Construction Change Order

**Change Order No.** 6  
**Contract No.** 23001015

AS SPLASH PARK CONSTRUCTION

CO #: 6 increases the PO by \$376,071.89 and extends it by 120 days to allow for the construction of four (4) pavilion shade structures, associated fencing, maintenance area improvements and associated general condition costs as detailed on the Scope of Work.

PROPOSED  
GROW AREA

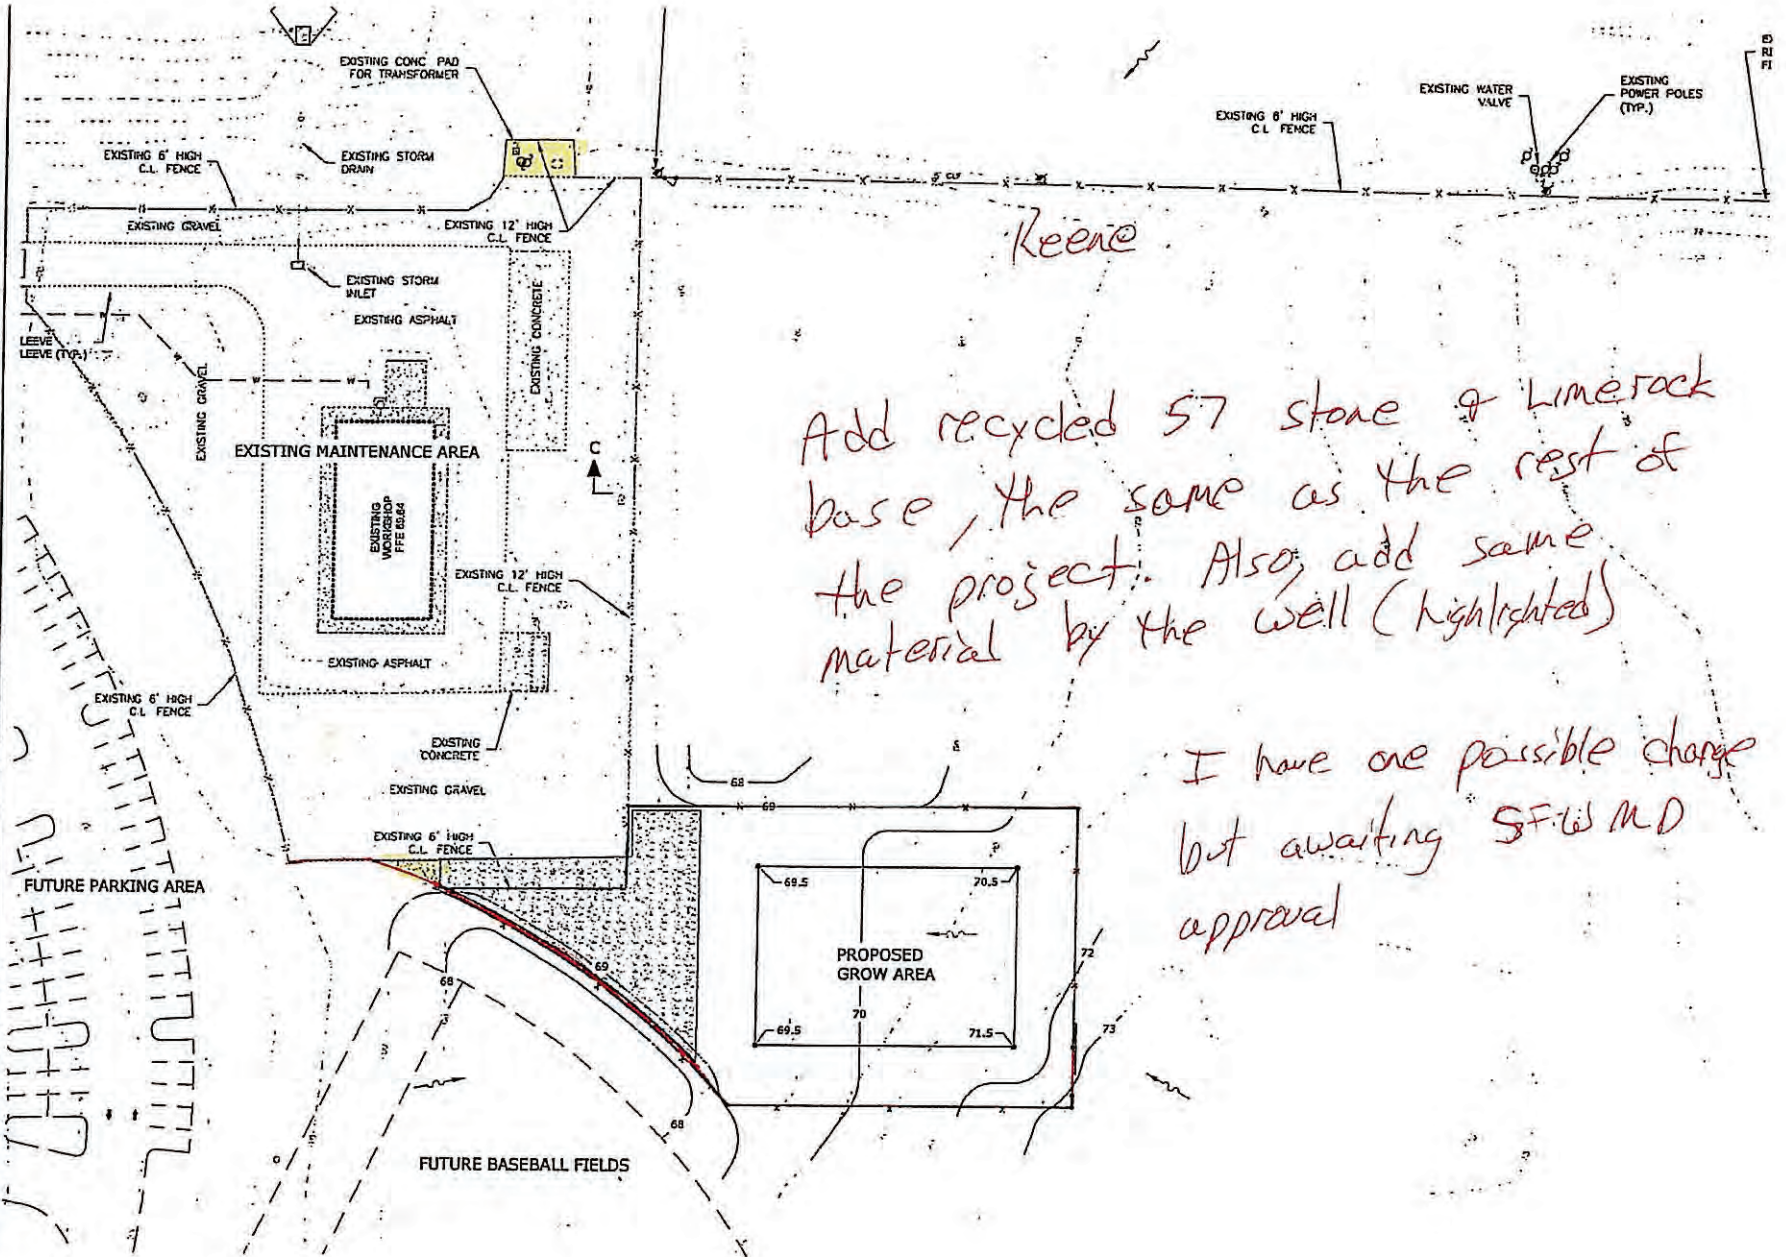
Add recycled 57 stone & Limerock base, the same as the rest of the project. Also, add same material by the well (highlighted)

GRADING, DRAINAGE, PAVING PLAN - PICNIC AREA  
ANDERSON SNOWSLOPE PARK  
PAGE 2

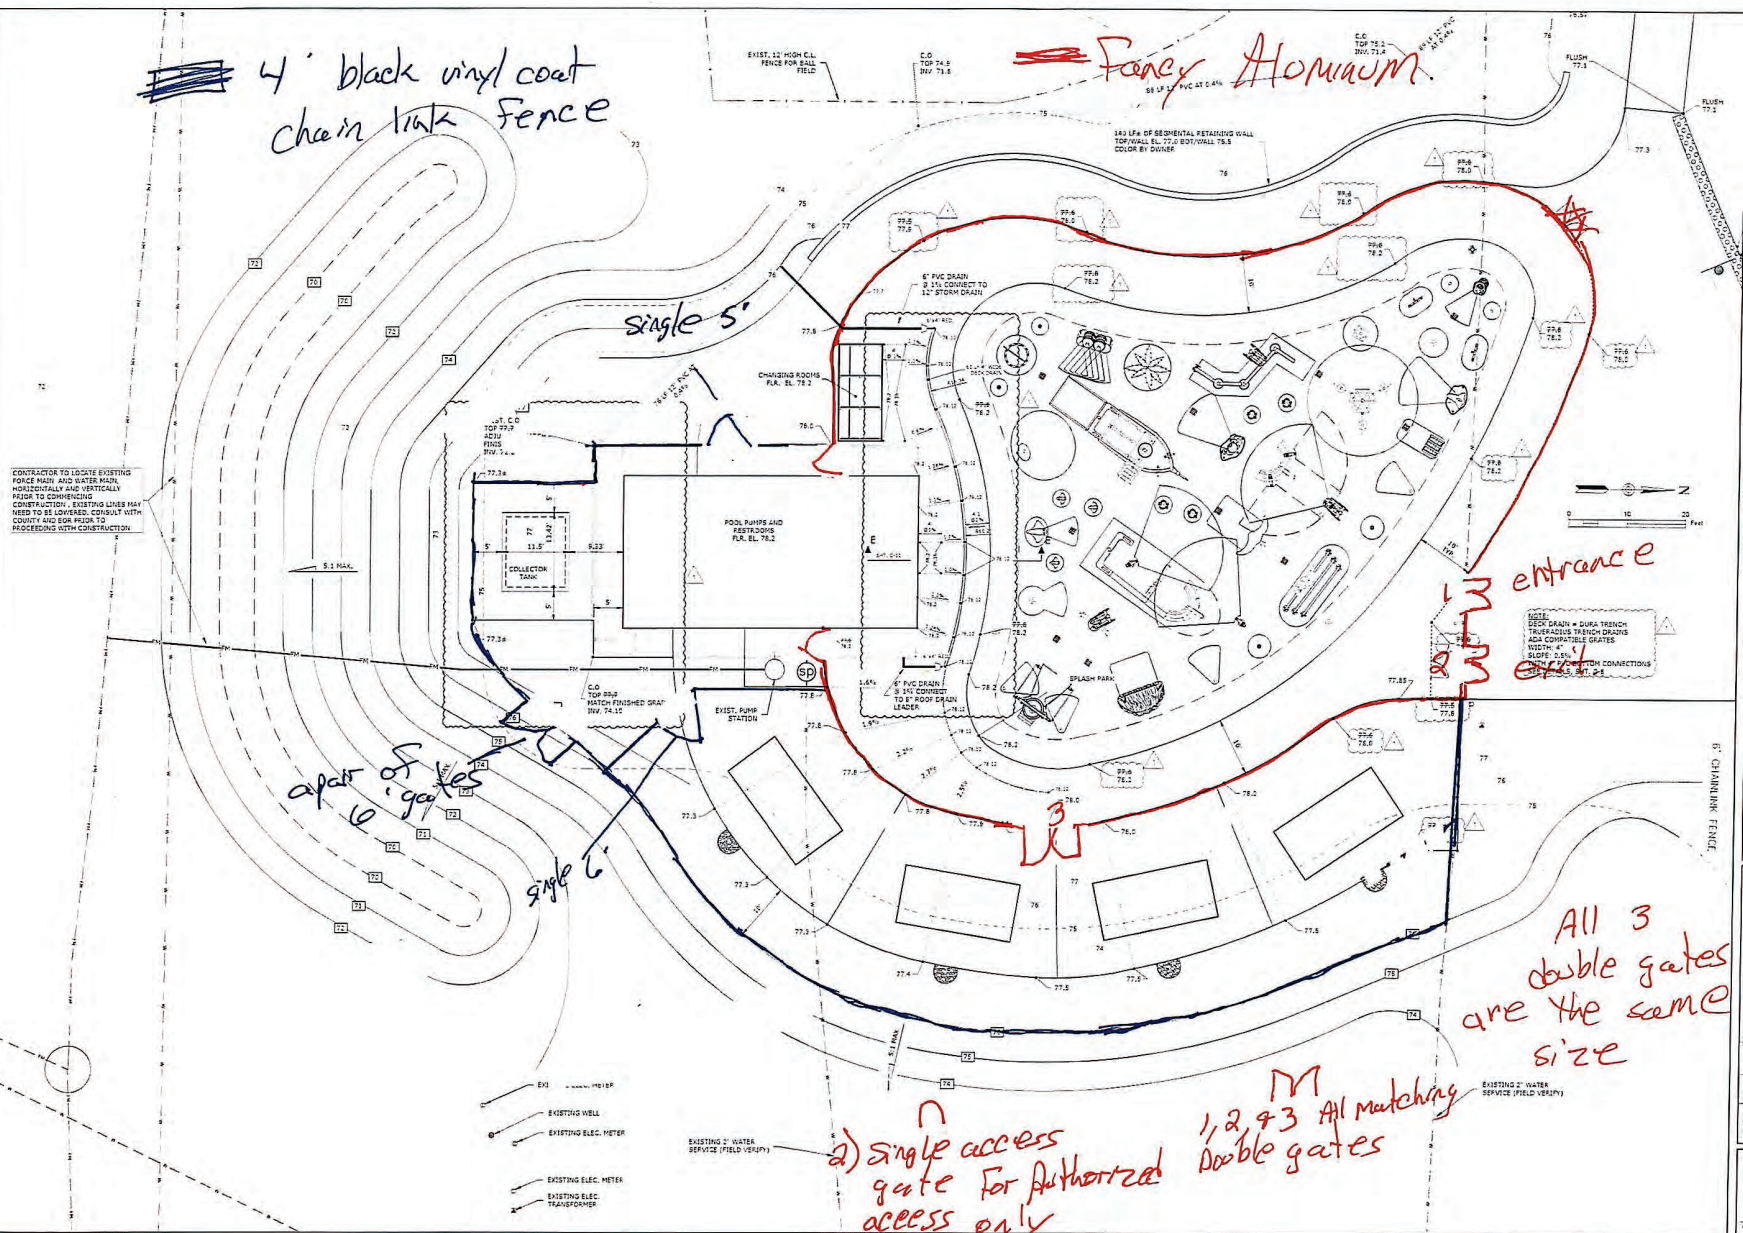
DESCRIPTION OF WORK	COST CODE	AMOUNT
Proposal for deck extension, retaining wall, fencing, picnic shelters and shade covers based on plans by Coastal Engineering, Picnic Area and Multi-Purpose Fields, specifically Sheets C-4, C-5 and C-9 See copy of change order proposal attached		\$206,188.10

The following is a brief description of the work required for the deck extension, retaining wall, fencing, picnic shelters and shade covers based on plans provided to us by your office by Coastal Engineering, Picnic Area and Multi-Purpose Fields, specifically Sheets C-4, C-5 and C-9.

<b>Fencing</b>	<ul style="list-style-type: none"> <li>• Provide &amp; install 147' of 4'H 6ga black chain link fence 2 ½" line posts, 3" terminal posts, 1 5/8" top rail and 6ga bottom tension</li> <li>• Provide &amp; install (1) 10'W X 4'H double swing gates in 4'H 6ga black chain link fencing with standard gate hardware</li> </ul>	<ul style="list-style-type: none"> <li>• \$9,013.00</li> </ul>
<b>Concrete</b>	<ul style="list-style-type: none"> <li>• Form, place and finish approx. 4064 SF of 4" concrete walkways and decking</li> </ul>	<ul style="list-style-type: none"> <li>• \$32,105.00</li> </ul>
<b>Pavillons</b>	<ul style="list-style-type: none"> <li>• Supply and install 4ea. 10' X20' X 9' shelters including 8" X 8" PT wood columns installed in concrete.</li> <li>• Roof structure is steel joist at 12" oc ,1x6 T&amp;G V joint pine and a 26 ga. screw down metal deck and matching eve trim.</li> </ul>	<ul style="list-style-type: none"> <li>• \$48,000.00</li> </ul>

SHEET  
**C-5**  
 21045-1

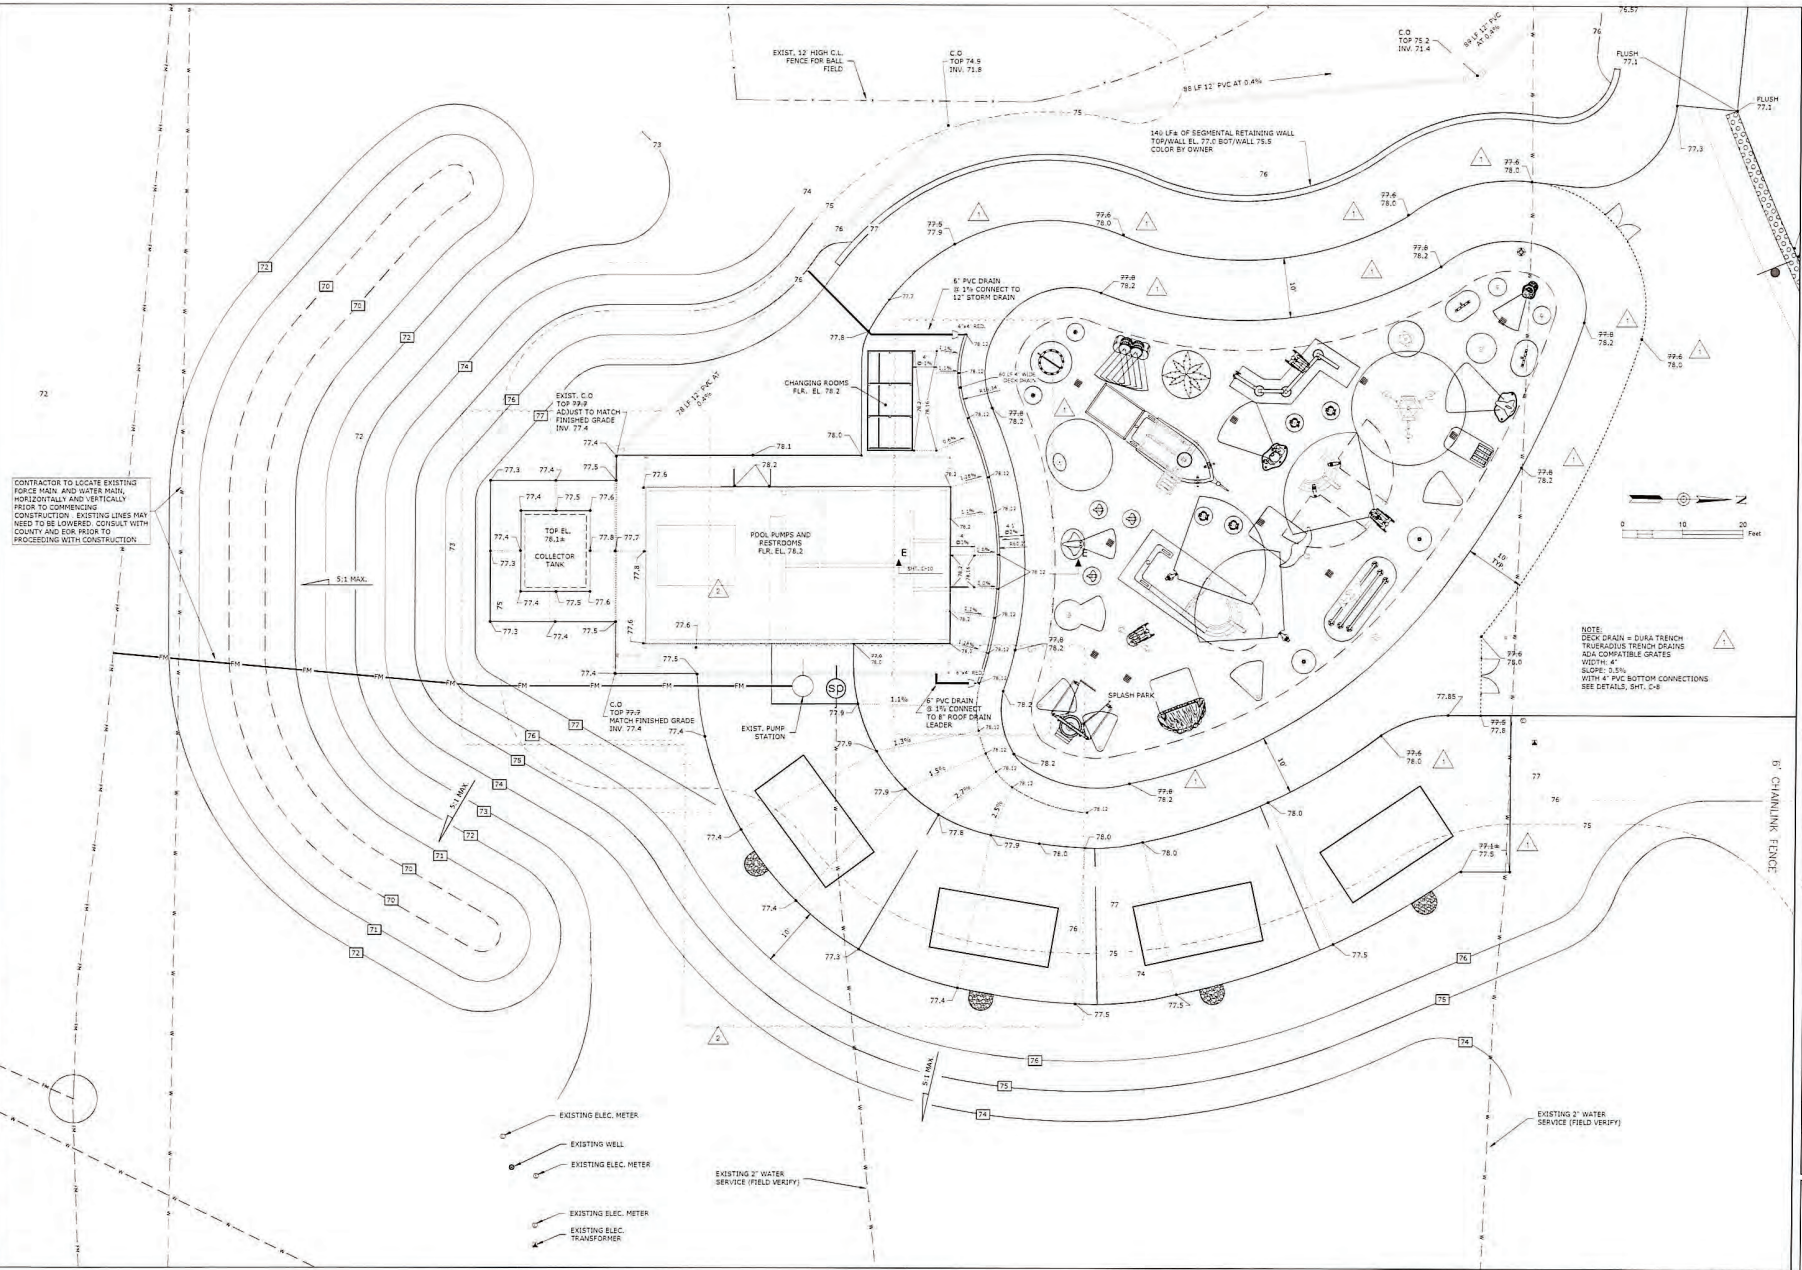
Please find the attached .PDF for the revised plan for requested slopes.  
This is the only way the slopes work out with the constraint of 2% slope way from the Splash Pad.

The curved pool deck drain is custom made by Dura Trench  
Plans need to be submitted to them.  
Contractor will need to contact local rep.  
We are proposing that the drains be connected to the existing/under construction storm drain system.

See attached revised grading for Phase 1 and Phase 2
